**PLANNED UNIT DEVELOPMENT
& SUBDIVISION STAFF REPORT****Date: November 2, 2017**

<u>DEVELOPMENT NAME</u>	Rangeline Crossing III Subdivision, Resubdivision of Lots 4 & 5
<u>SUBDIVISION NAME</u>	Rangeline Crossing III Subdivision, Resubdivision of Lots 4 & 5
<u>LOCATION</u>	(North side of Rangeline Road Service Road 904'± East of Halls Mill Road)
<u>CITY COUNCIL DISTRICT</u>	District 4
<u>AREA OF PROPERTY</u>	2 Lots / 2.1 ± acres (Subdivision) 7 Lots / 78.3 ± acres (PUD)
<u>CONTEMPLATED USE</u>	Planned Unit Development Approval to amend a previously approved Planned Unit Development to allow shared access between multiple lots to accommodate a proposed paint warehouse and retail store.
<u>TIME SCHEDULE FOR DEVELOPMENT</u>	None given.
<u>ENGINEERING COMMENTS</u>

SITE PLAN

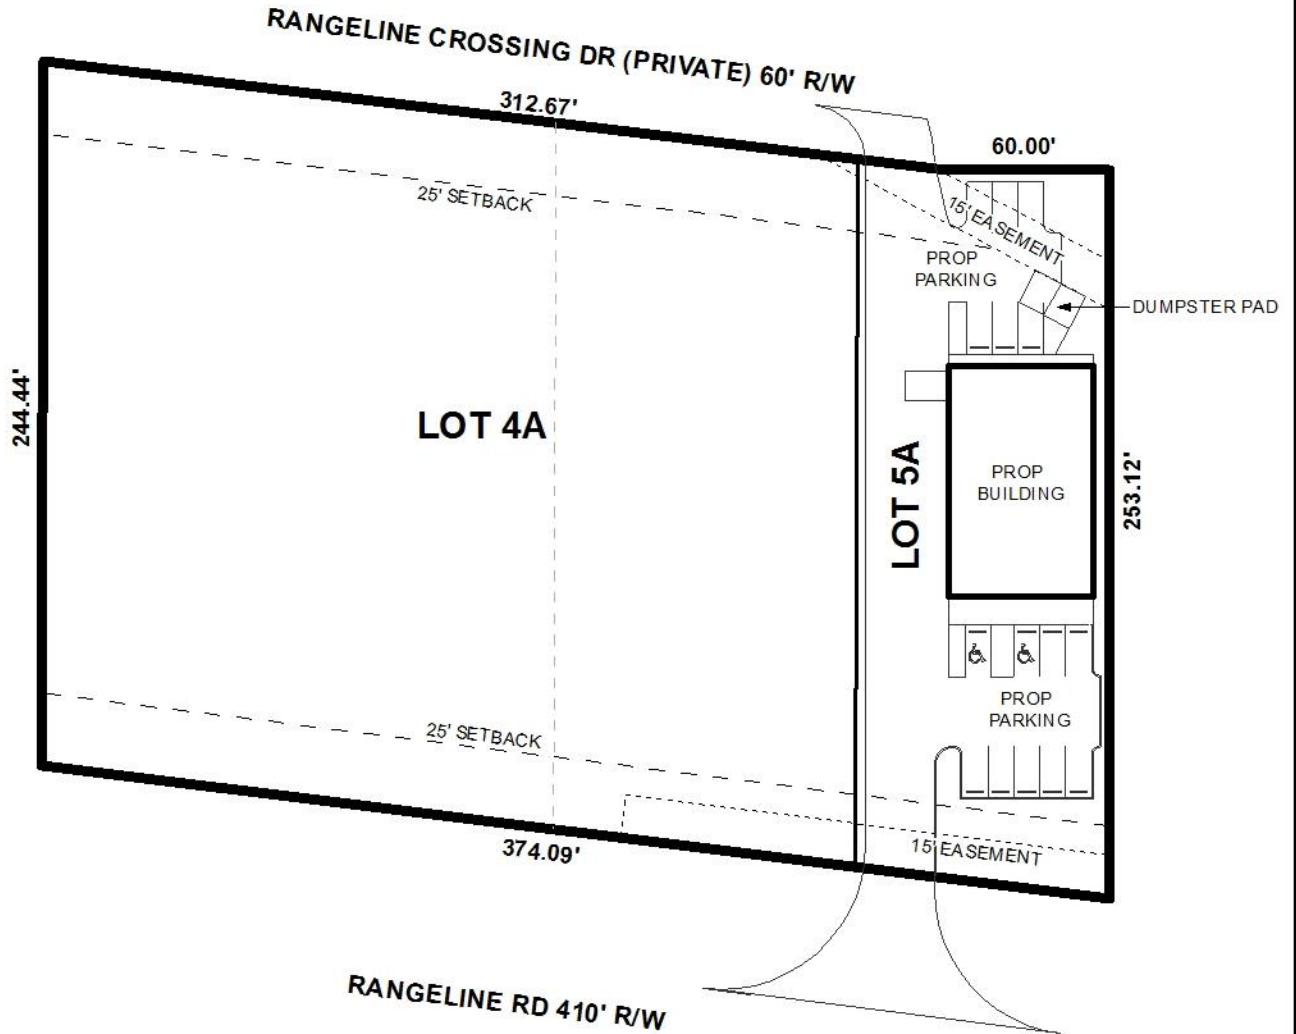
The submitted site plan for the PUD does not include the site plan for the previously approved VA property. The proposed Lot 5A has less than 30' of frontage on the (private) Rangeline Crossing Drive. A standard driveway requires 64' of frontage otherwise the driveway will extend over the property line. The proposed layout of the driveway onto Rangeline Crossing Drive is substandard and not recommended. The plan should include the previously approved VA site and its driveway so that the two designs can be clarified with the PUD approval. Based on comments from ALDOT regarding access on the Service Road, the driveway to Rangeline Crossing should be considered as a shared driveway with Lot 4A and may be better suited to split the property line. The shift of the aisle can provide some relief for the driveway on the north side as well. Confirmation of ALDOT driveway approval will be required prior to permitting for site work on each lot. Enlarged Lot B does not clearly indicate whether the westernmost driveway on Rangeline Service Road is included and may conflict with the overall site layout.

Because of the size of the overall PUD site and the proximity of the site to Rangeline Road, an ALDOT maintained facility, access management is a concern. The PUD site plan shows that the proposed fast-food lot will have one curb-cut to the Rangeline Service Road North, and two curb-cuts to the proposed private roads (Rangeline Crossing Drive) within the development. The proposed clinic is depicted as having two curb-cuts to Demetropolis Road and one curb-cut to the proposed private road. The clinic additionally abuts the proposed public street (Yogger Pass), and access to this street can be granted via one curb-cut once that street is built and accepted for maintenance by the City of Mobile; however, once access is obtained to Yogger Pass, the clinic's most northern access point to Demetropolis Road should be closed due to possible traffic conflicts. With the exception of future access by the clinic site to Yogger Pass, all other lots within the PUD should be limited in terms of the number of curb-cuts as depicted on an approved PUD site plan. Furthermore, the proposed curb-cuts for Lot 5A depict one curb-cut to Rangeline Road and one curb-cut to Rangeline Crossing Drive. The curb-cut depicted along Rangeline Crossing Drive is located in an undesired location and as it is extremely close to the clinic driveway and appears that it may cause traffic flow issues. It is staff's opinion that a shared curb-cut between Lot 4A and Lot 5A will be more functional and a more appropriate location.

The 25’ minimum building setback lines are depicted on the site plan and the plat; however, it appears that the setback line does not continue across the entire length of the proposed Lot 5A. the plat and site plan should be revised to depict the 25’ minimum building lines for the entirety of both properties.

Several drainage, access and utility easements are depicted on the preliminary plat and the PUD site plan. The note stating “structures that are not associated with the purpose of the easement shall not be placed within any easement” should be retained on both the plat and site plan.

1. submission of a Master Plan for the entire PUD development;
2. submission of a revised site plan depicting a shared curb-cut between Lot 4A and Lot 5A to the private Rangeline Crossing and the public Rangeline Road Service Road;
3. revision of the site plan and subdivision plat to depict the 25’ minimum building setback lines across the entire property line of Lot 5A; and
4. revision to depict compliance with Traffic Engineering comments: *“A traffic impact study was has been prepared for this site. The study includes off-site improvements along*

DETAIL SITE PLAN

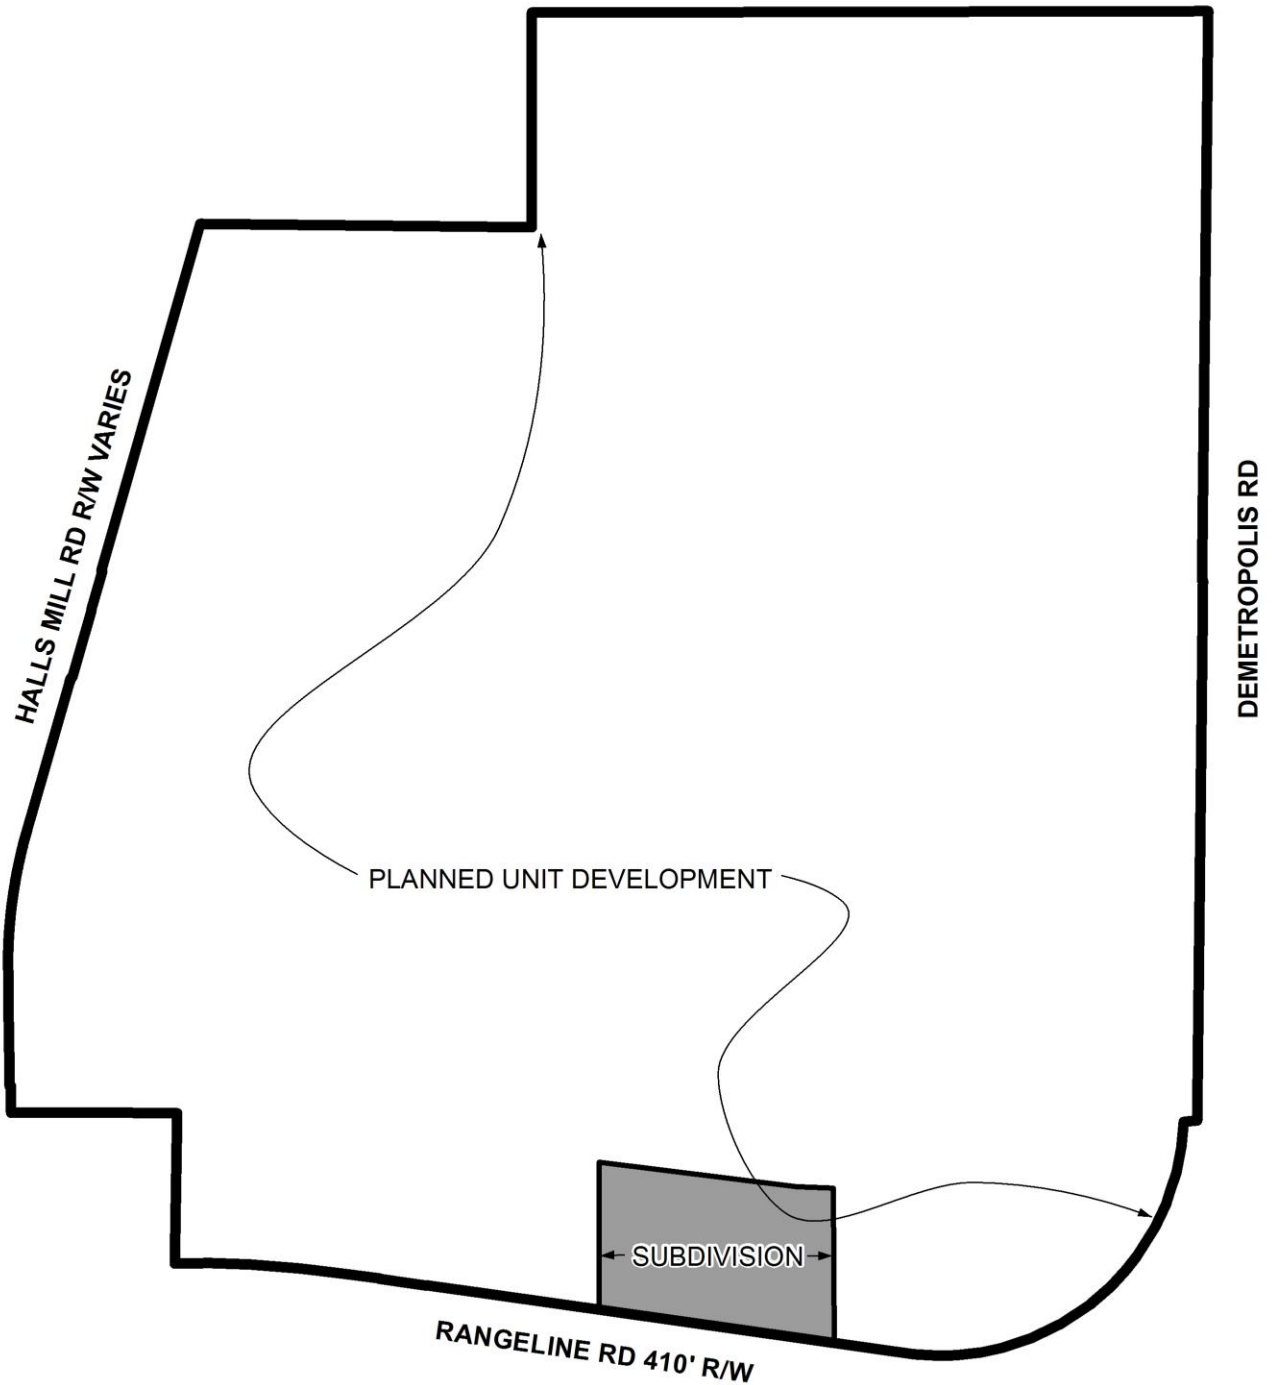
The PUD site plan depicts Lot 5A as having a commercial paint warehouse and retail store developed on the site with what appears to be compliant parking; a dumpster in compliance with

Section 64-4.D.9. is depicted on the site plan and the note should be retained on any future site plans. The note stating “full tree planting and landscape requirements will be meet and in compliance with Section 64-4.E of the Zoning Ordinance” should be retained on future site plans.
